WAITOMOKIA PRECINCT – RESPONSE TO RFI

You have submitted a plan change application to Auckland Council to create a new Auckland Unitary Plan (AUP) Precinct. The new Precinct is called Waitomokia Precinct and is located in Māngere, approximately 3km north of Auckland Airport. Appendix A shows the location plan.

MARSHALL DAY ACOUSTICS LTD

APPENDIX B ZONING

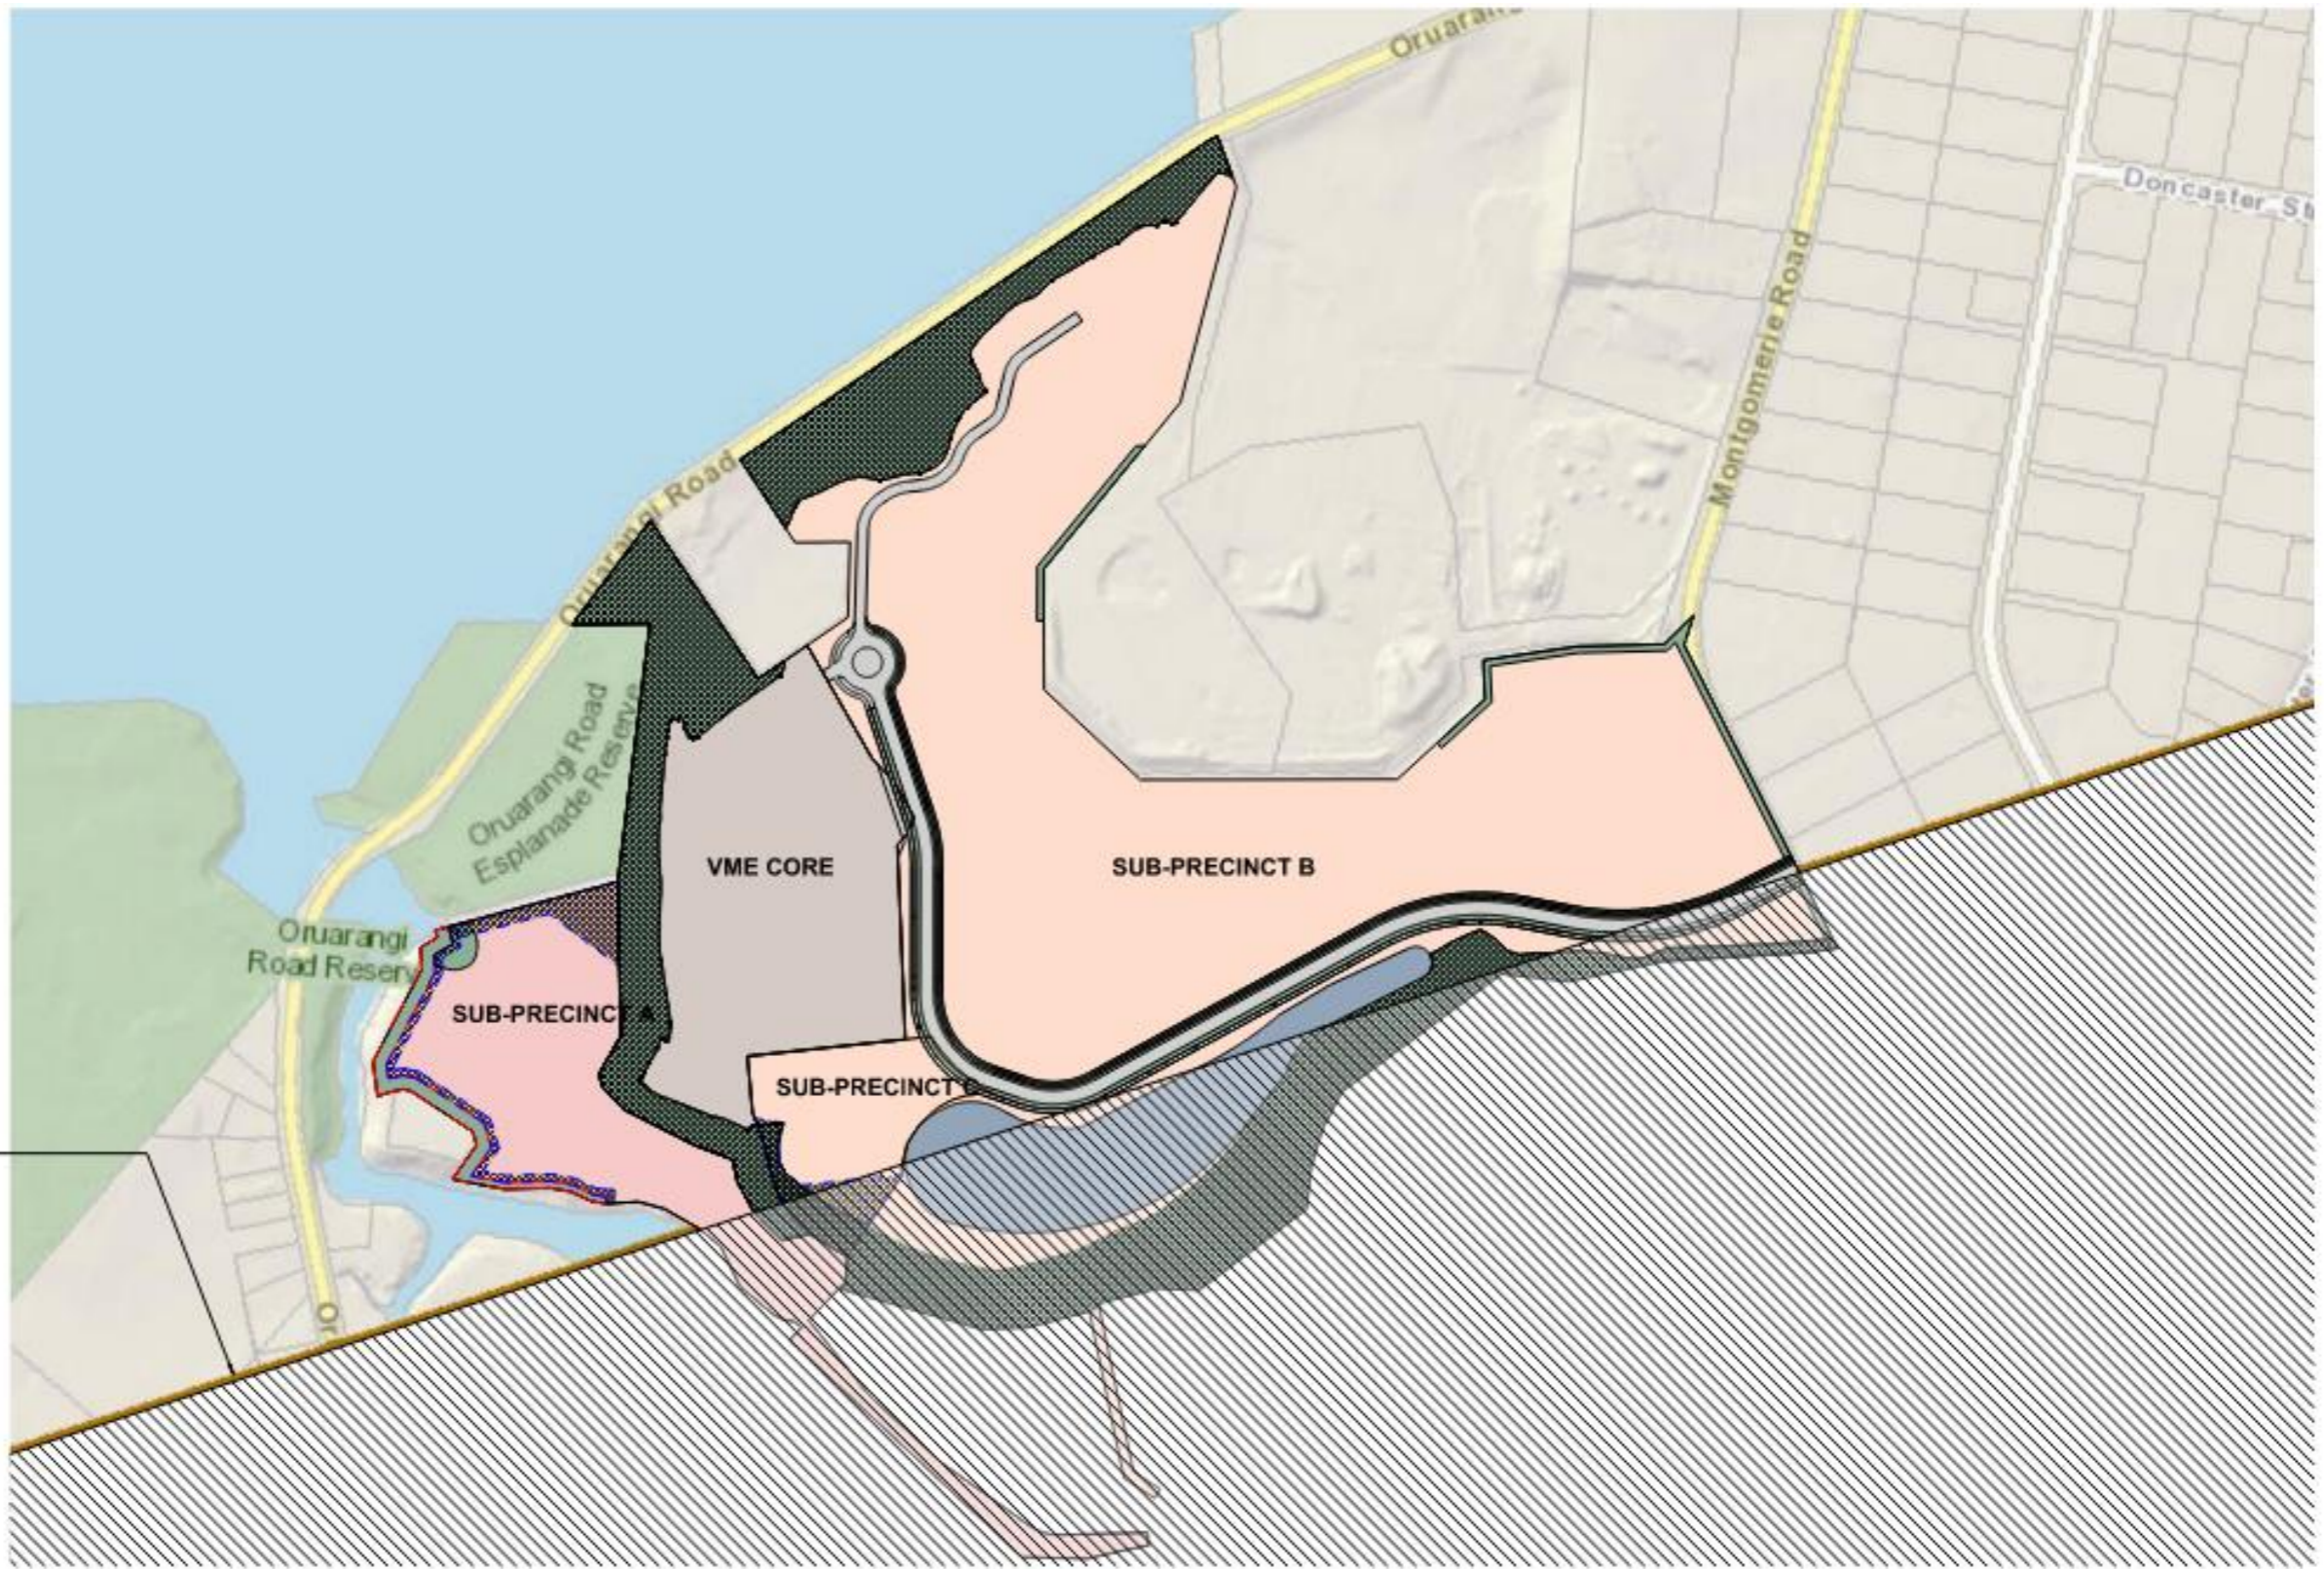
The Precinct is currently zoned as *Business – Light Industry* (see Appendix B). The plan change does not seek to change the zoning. The zoning maps also shows the Aircraft Noise Overlay in relation to the location plan. Goodman has shown this overlay on their master plan (see Appendix C). We consider that the Aircraft Noise Overlay does not cover any of the proposed building areas. We consider that there will be no reverse sensitivity effect on Auckland Airport.
